Enclosure (1) is the Responses to Agency Comments on the Draft Storm Water Discharge Management Plan, Installation Restoration Site 01/21, Industrial Landfill, Parcel E Hunters Point Shipyard of January 7, 2003.

**RESPONSES TO REGULATORY AGENCY COMMENTS ON THE
DRAFT STORM WATER DISCHARGE MANAGEMENT PLAN, IR-01/21,
INDUSTRIAL LANDFILL, PARCEL E
HUNTERS POINT SHIPYARD, SAN FRANCISCO, CALIFORNIA**

This document presents the U.S. Department of the Navy's (Navy) responses to comments from the California Regional Water Quality Control Board (RWQCB) San Francisco Bay Region on the "Draft Storm Water Discharge Management Plan, IR-01/21, Industrial Landfill, Parcel E, Hunters Point Shipyard, San Francisco, California," dated January 7, 2003. The comments addressed below were received from RWQCB on March 3, 2003.

Photo 1. Jute mat within a portion of the drainage ditch along the north side of the facility surrounded by large area of unprotected dirt.

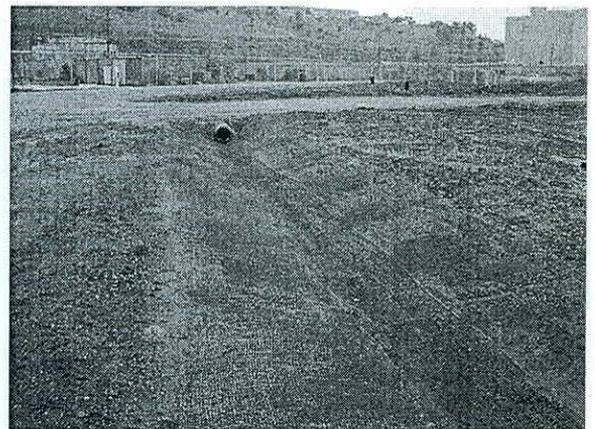
- 1. Comment:** During Board staff's February 12, 2003 inspection of the landfill, it was observed that although a vegetative cap covers much of the landfill, there are large areas, including roads, portions of the landfill cap, and drainage ditches that are within areas that are completely unprotected (see Photos 1 and 2). The existing Best Management Practice (BMP) implementation was not in compliance with the State Water Resources Control Board General Permit for Storm Water Discharges Associated with Industrial Activities (NPDES Permit No. CAS000001 – Industrial General Permit), which requires identification and implementation of BMPs that will effectively prevent discharges of pollutants to waters of the State.

Appropriate BMPs should be implemented immediately in these areas to prevent further erosion, which could result in a discharge of sediment or other contaminants into drainage ditches, catch basins, and the San Francisco Bay. The post-construction BMPs described in the General Permit for Storm Water Discharges Associated with Construction Activity (SWRCB Order No. 99-08-DWQ – Construction General Permit) are considered by Board staff to be appropriate BMPs to utilize under the Industrial General Permit, because the subject facility is primarily unpaved and includes areas that have been recently disturbed by construction activities.

Response: Construction was completed on the landfill gas control system in October 2002. The storm water discharge management plan (SWDMP) was issued after construction and was intended for IR-01/21, an industrial landfill site with only maintenance activities associated with the landfill cap. The SWDMP, therefore, follows the substantive requirements of the State Water Resources Control Board General Permit for Storm Water Discharges Associated with Industrial Activities rather than construction activities. The best management practices (BMP) implemented are identified in Section 4.3.8 of the SWDMP. These included fiber rolls, vegetation, erosion control matting (jute matting), and silt fences. These erosion and sediment controls are in compliance with the Industrial General Permit because they prevent discharges of pollutants from the site and into San Francisco Bay (Bay). These BMPs are consistent with the maintenance BMPs discussed in California Department of Transportation Statewide Storm Water Quality Practice Guidelines (California Department of Transportation 2002). These BMPs are also listed as erosion and sediment controls in the General Permit for Storm Water Discharges Associated with Construction Activity. The Construction General Permit, however, does not apply to this site for the reasons explained below.
